Analysis of Return Loss Limits

Contribution to 802.3dm Task Force

February 27, 2025

Ragnar Jonsson - Marvell

Impedance distribution, assuming that 1/1000 cables have $|Z_0| > 3\Omega$

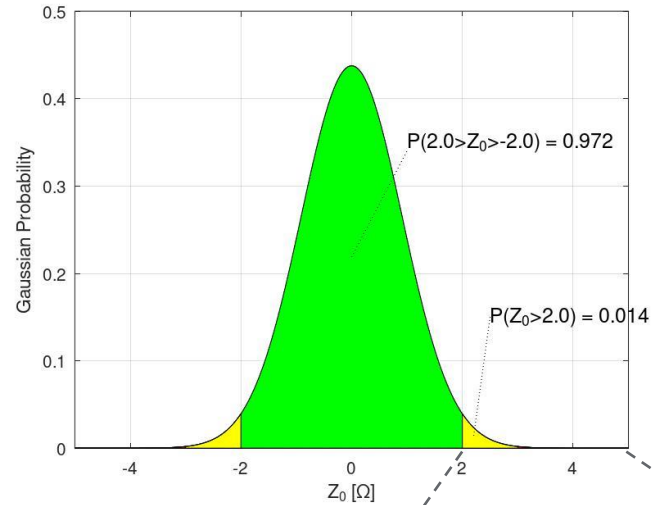
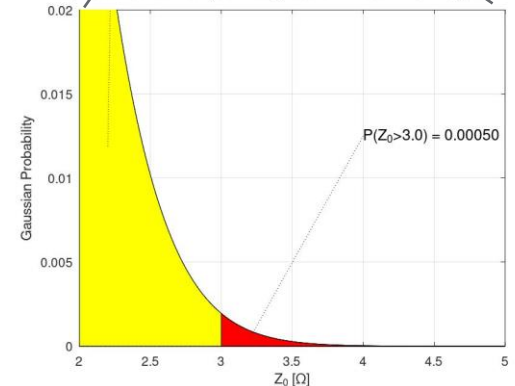
- According to ISO 19642-11 the coax cables of interest for 802.3dm must have less than 3Ω impedance mismatch ($|Z_0| < 3\Omega$)
- The plot on the right shows the probability distribution function (PDF) for cable impedance, assuming that the distribution is Gaussian and that one in 1000 cables violates the 3Ω limit
- For this case the probability of having impedance variation above 2Ω would be 1.4% (see top plot on the right)

Recreating ASA Simulation Results

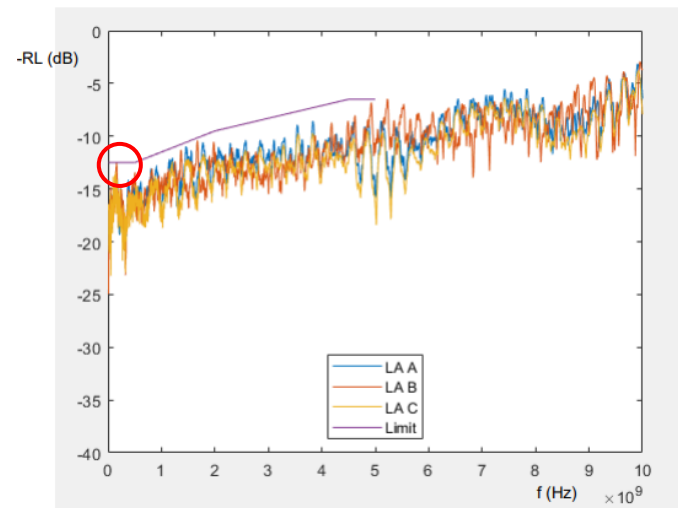
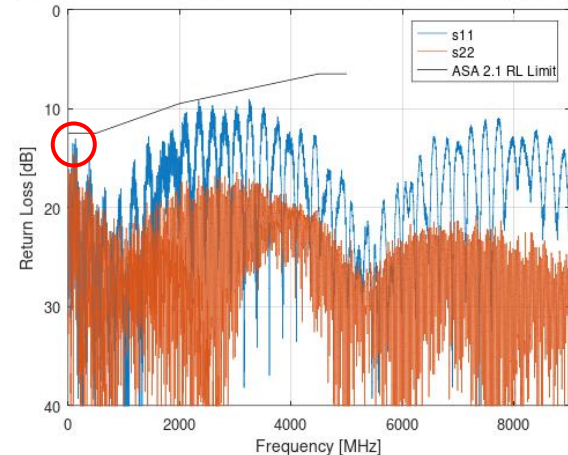
- The simulation results for ASA 2.1 RL limit have been shared with 802.3dm (see top right)
- The plot on the bottom right shows the corresponding return loss generated in my simulation
- The difference between the plots is primarily due to the different connector models used
- Notice that both simulations show the high peak at low frequency (in red circles), which is due to alternating impedance values

Good vs Bad Connectors

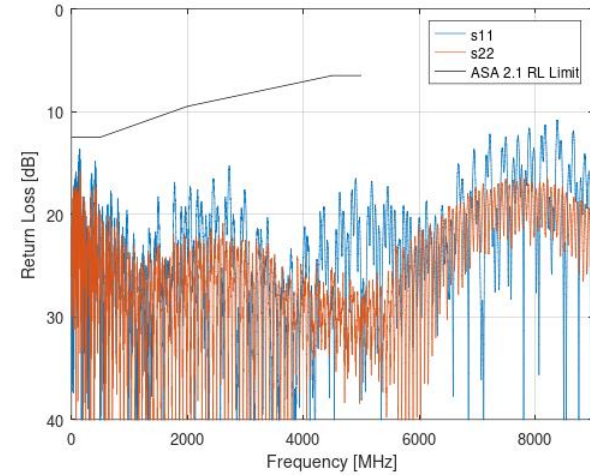
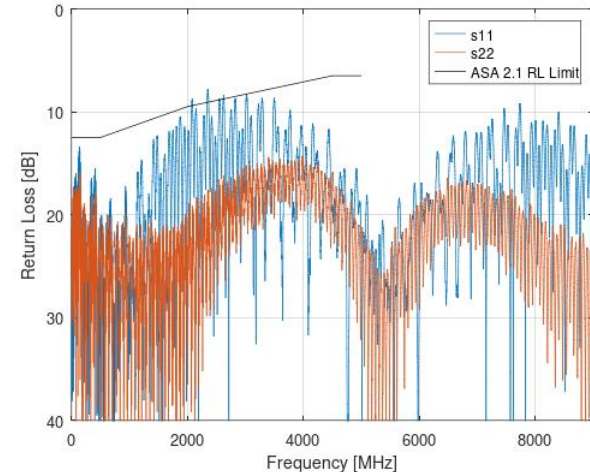
- The plots on the right show the difference in echo (return loss) for identical cables, except one of them has good connectors while the other one has bad connectors
- The bad connector has return loss that is touching the USCAR49 return loss limit
- Observe that the return loss for the cable with bad connectors is violating the ASA return loss limit

Extreme vs Bad Cable Impedance Variations

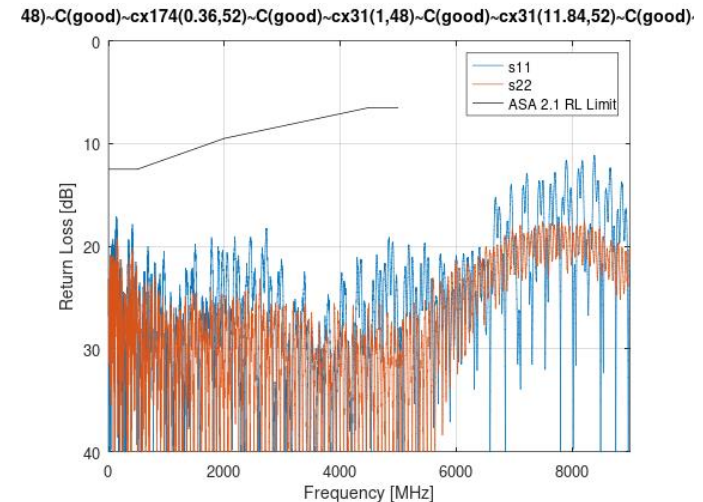
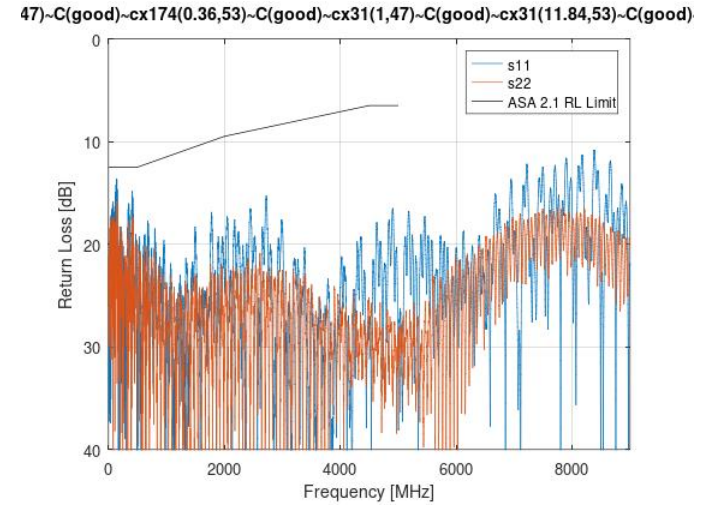
- The figure on the top right shows the return loss for extreme cable impedance variations of ± 3 Ohm
- The figure on the bottom right shows the return loss for bad cable impedance variations of ± 2 Ohm
- There is significant difference in the low frequency echo for the two cases
- The probability of encountering the extreme impedance variations shown on the top right are extremely small
